Access Compliance Report

Public Rights-of-Way

Intersection ID: 2877	Main Street: GOLDENFIELD_DR	Cross Street: FOGGY_MEADOW_RD	Location:	N
ADA ID: 919D1A0D233C	Ramp Type: Perp	Initial Pass/Fail: Pass	Overall Compliance: No	Severity Score: 0

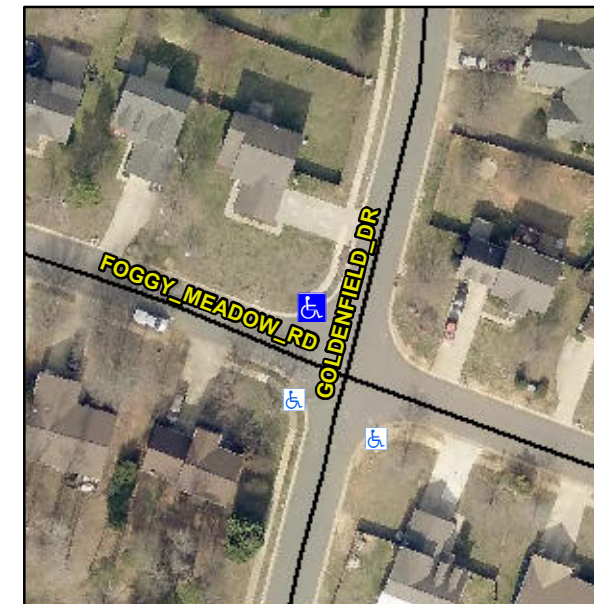
**Not Found, R304.2.1, R304.2.2-Perp,
R304.3.2-Para, R304.5.3, R305.2**

**Remove & Replace Entire Ramp.
Remove & Replace Gutter.**
